CONSTRUCTION SUMMARY

2185715 Ontario Inc.

LOT NUMBER	PHASE	HOUSE TYPE	CLOSING DATE	
004	1	MADISON-STD MAIN-5 BEDROOM-ELEVATION C

. LOT 4 . Madison . 45-05 . STANDARD MAIN - 5 BEDR.

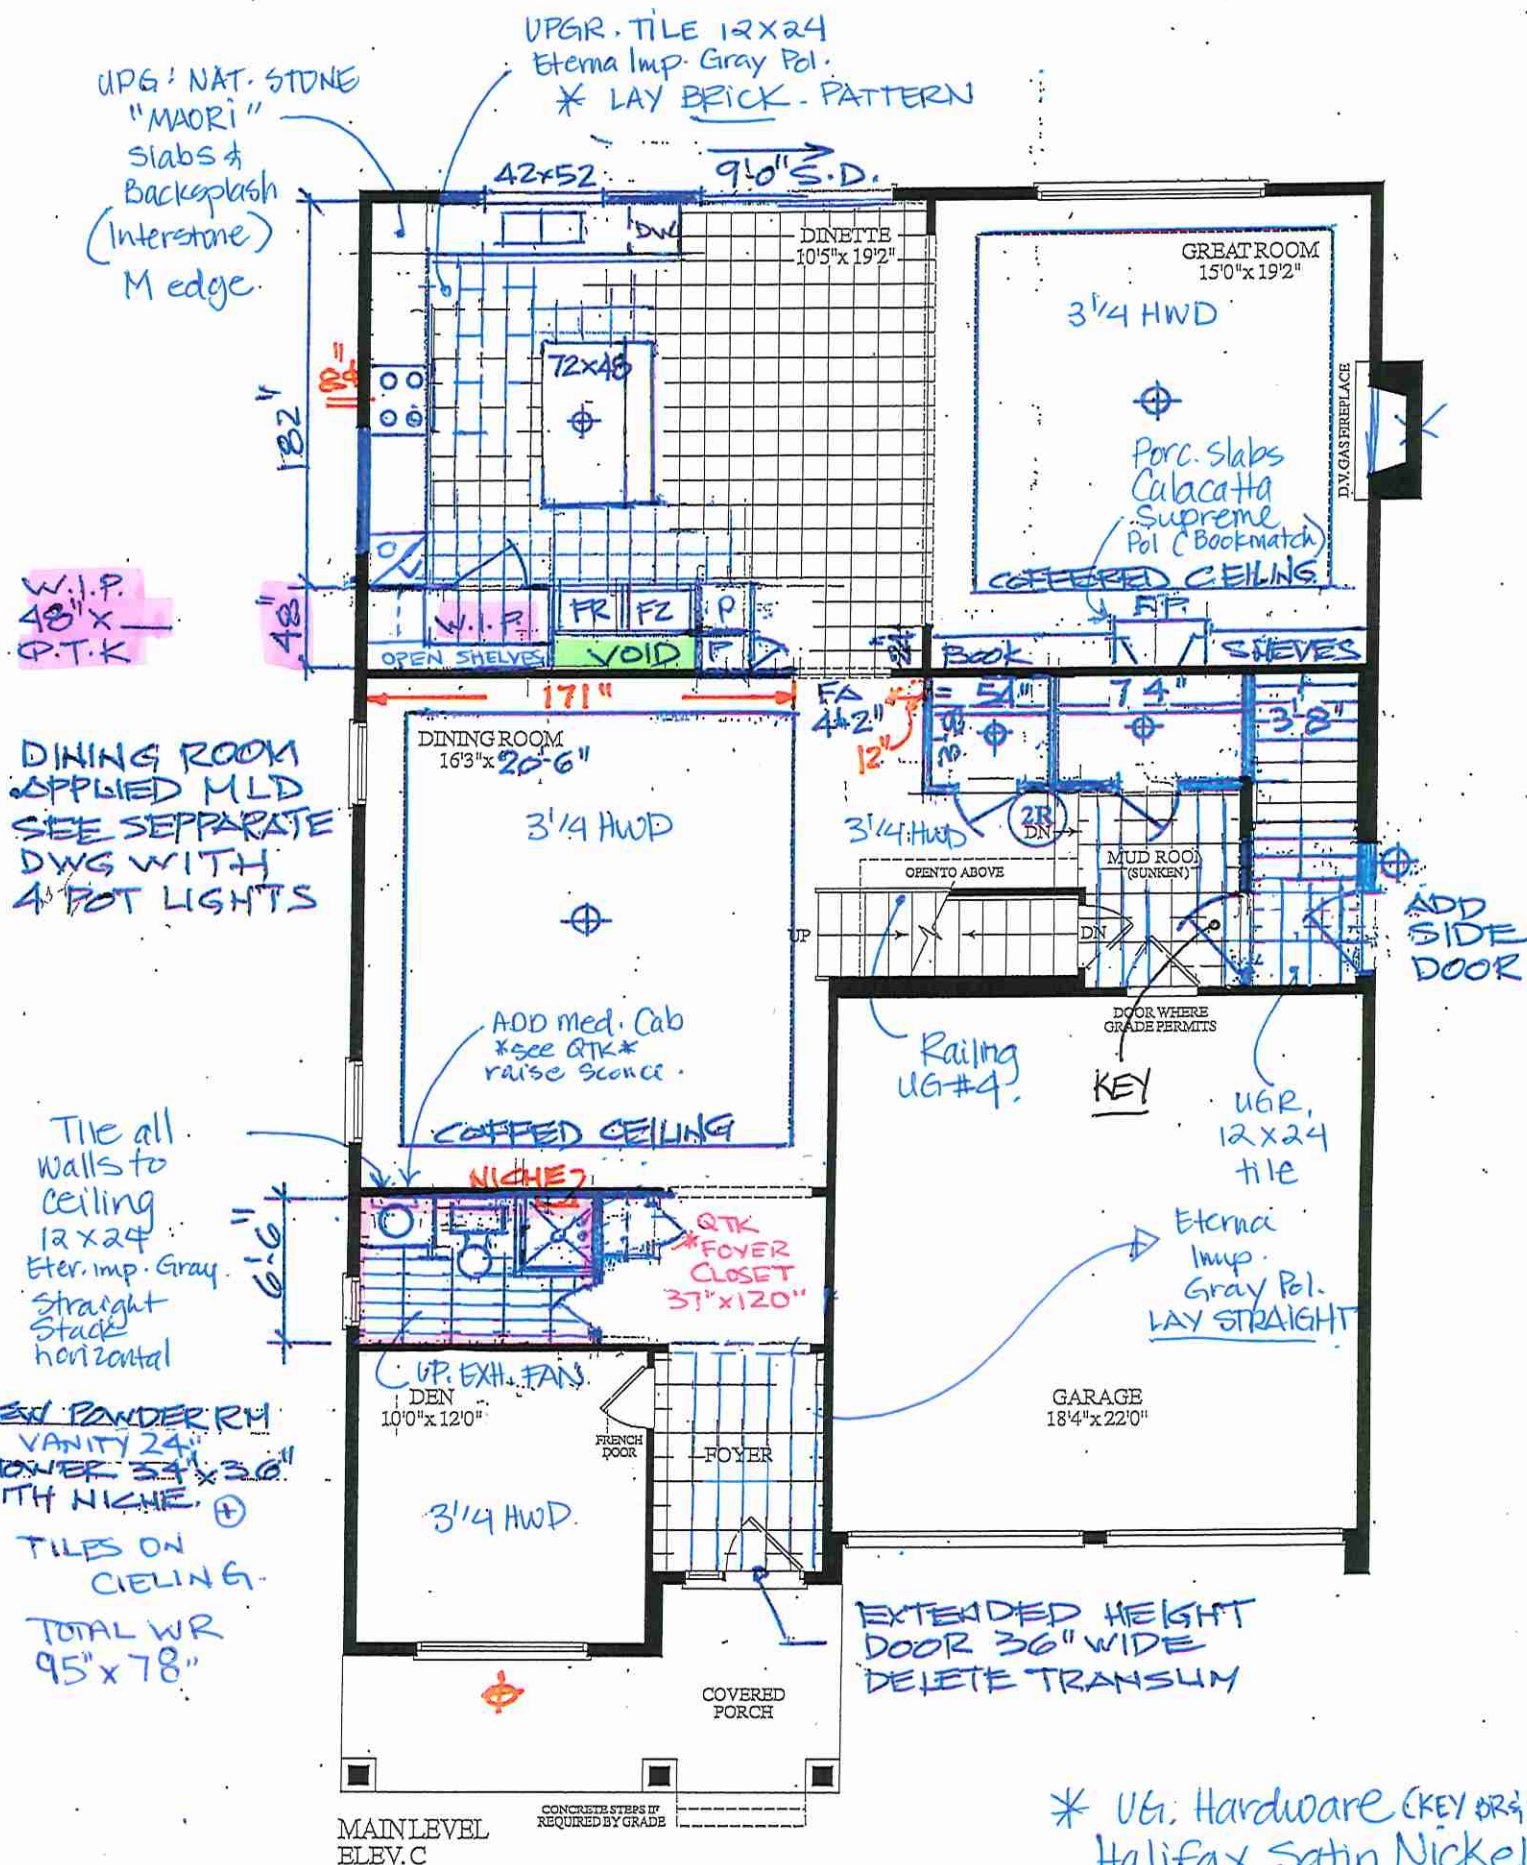
- RELOCATE SINK + WINDOW TO BACK WALL
- DELETE 2-24X68 WINDOWS + SHIFT SLIDING DOOR
- GAS LINE TO STOVE
- 8" EXHAUST PIPE
- WATER LINE TO FRIDGE + FREEZER

• Add 4 pots.

ADD'L jaws
to ceiling w/ quartz
DUMMY WALL
WITH 20" x 16"
NICHE

ADD 8 POTS
keep stair pendant

ADD
internet
cable
and
outlet.

KITCHEN - PLAN

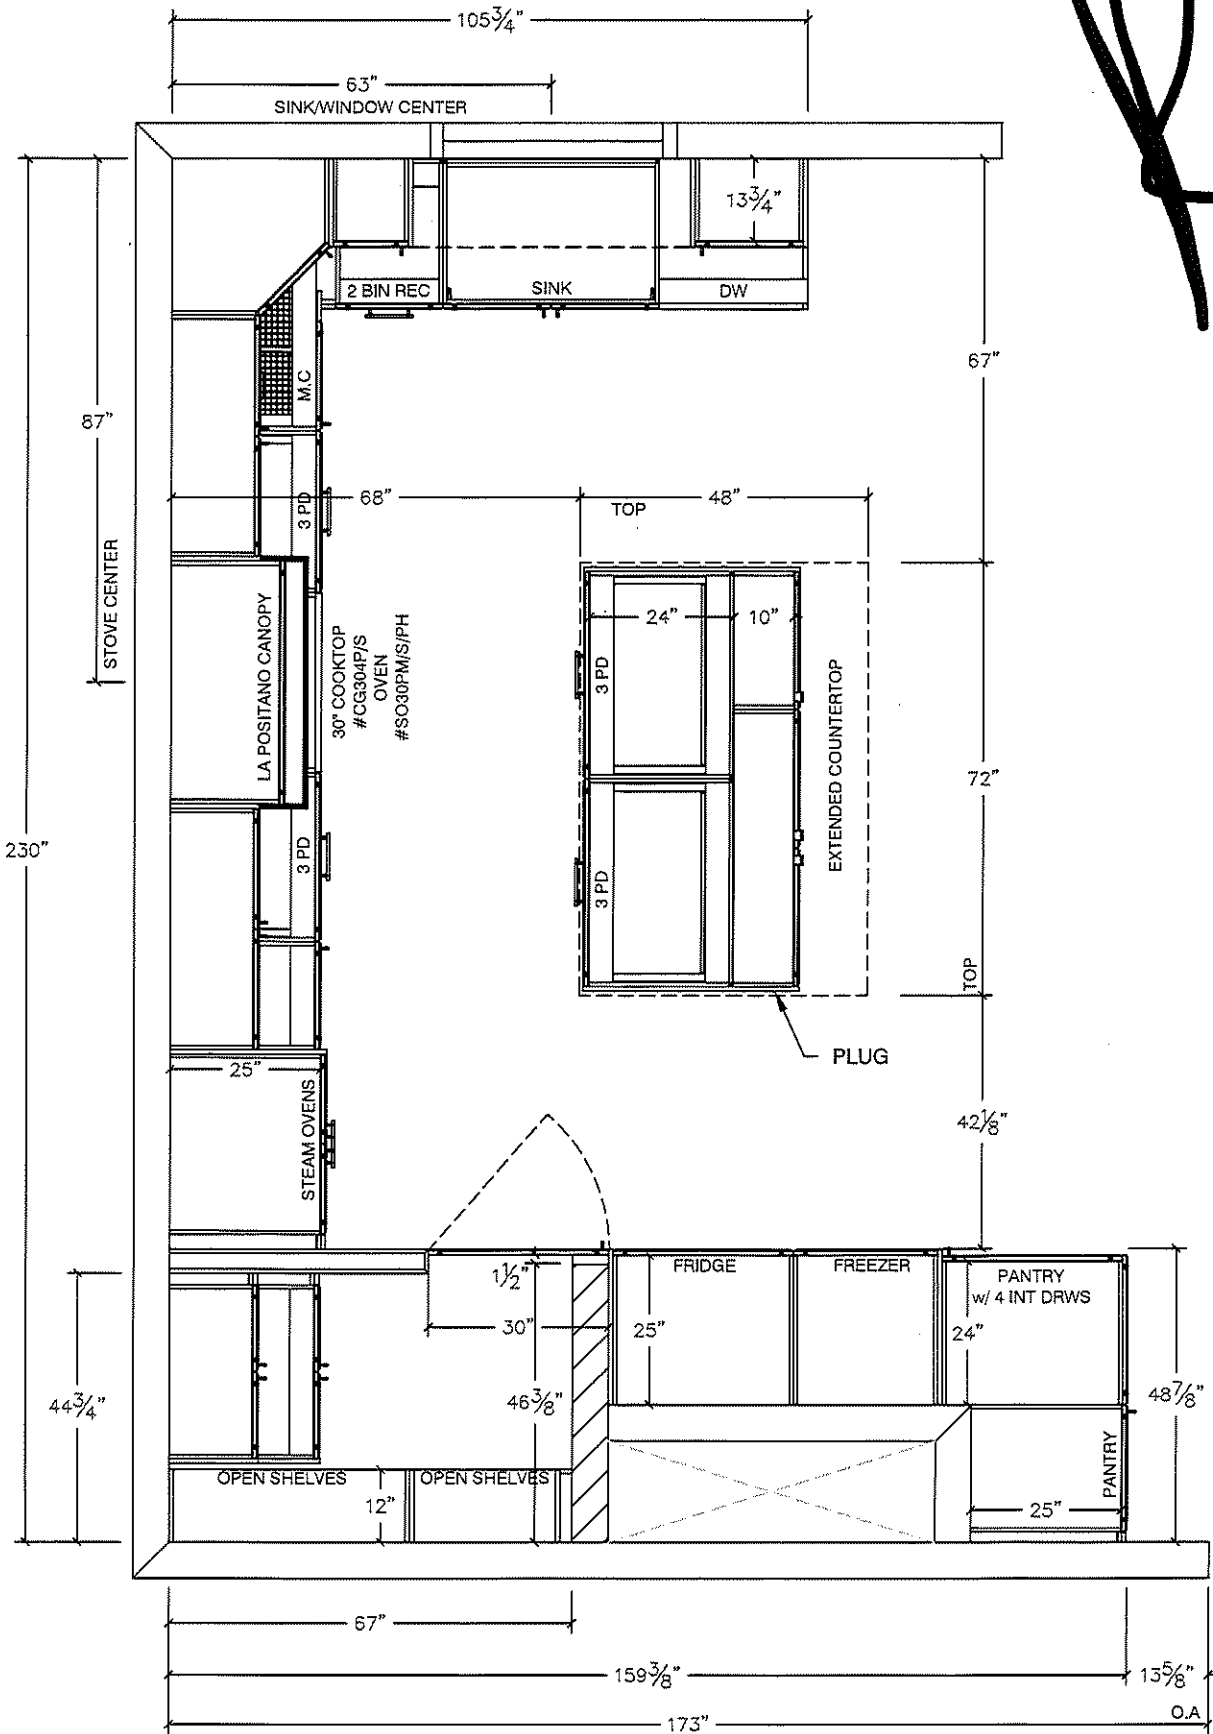
1 - DINING ROOM & GREAT ROOM - ADD POT LIGHTS - ADD 6 (OUT OF 10 GIFTED POTS) POT LIGHTS IN GREAT ROOM & 4 (OUT OF 10 GIFTED POTS) POT LIGHTS IN DINING ROOM (SEE PLAN). STANDARD LIGHT TO REMAIN Note:
1 - DEN - ADD 7" SERIES CROWN MOULDING IKN D16A AT PERIMETER OF ROOM. Note:
1 - KITCHEN -- ADD 8 INCH EXHAUST DUCTING - IN LIEU OF 6 INCH**SEE PLAN FOR NEW LOCATION** Note:
1 - KITCHEN - *RELOCATE WINDOW AT KITCHEN SINK* (EXTERIOR WALL CONSTRUCTION/BRICK) (SEE PLAN) Note:
1 - KITCHEN - BACK EXTERIOR WALL - RELOCATE 9' SLIDING DOOR TOWARD GREAT ROOM - AND RELOCATE WINDOW OVER NEW SINK LOCATION (REFER TO SKETCH) BACK EXTERIOR ELEVATION AS PER "PARTIAL MAIN LEVEL WITH OPTIONAL KITCHEN" **delete 2 (two) 24 in x 68 in windows** Note:
1 - KITCHEN - RELOCATE SINK AND DISHWASHER TO BACK EXTERIOR WALL UNDER WINDOW. AS PER SKETCH Note:
1 - KITCHEN - RELOCATE GAS STOVE TOP AND 8" EXHAUST - (REFER TO PLAN) Note:

1 - KITCHEN - ADDITIONAL ELECTRICAL RECEPTACLE- GFI - INTERIOR WITH DEDICATED LINE - FOR NEW COLUMN FREEZER 24" WIDE \$350, RELOCATE STANDARD FRIDGE RECEPTACLE \$250 FOR COLUMN FRIDGE 30" WIDE (SEE PLAN FOR LOCATIONS) Note:
1 - KITCHEN CABINETS - add'l base & uppers. cabinets to back side of island. wall oven tower (speed & steam). cooktop with oven below. prof series fridges. 4 inter pntry drwrs. walk in patry frame by QTK w QTK door, base and upper cabinets & 14"d shlv Note: ADD'L UPPER DEPTH CABINETS TO BE ADDED TO UNDERSIDE OF KEE SPACE AT ISLAND INCREASING OVERALL DEPTH TO 48". APROX LENGTH OF ISLAND 72" \$15,880 plus \$6000 for QTK pantry enclosure *all pricing based on standard cabinet doors and heights as per sched A*
1 - KITCHEN PANTRY - ADDITIONAL PENDANT ON SINGLE POLE SWITCH Note:
1 - POWDER ROOM: ENLARGE POWDER ROOM TO ADD STANDING SHOWER. INCLUDES 2X2 MOSAIC FLOOR TILES, 6" WHITE QUARTZ CURB PLUS SHOWER POT LIGHT. FULLY FRAMELESS GLASS ENCLOSURE TWO SIDED - SEE PLAN. Note: note: dining room may be reduced slightly
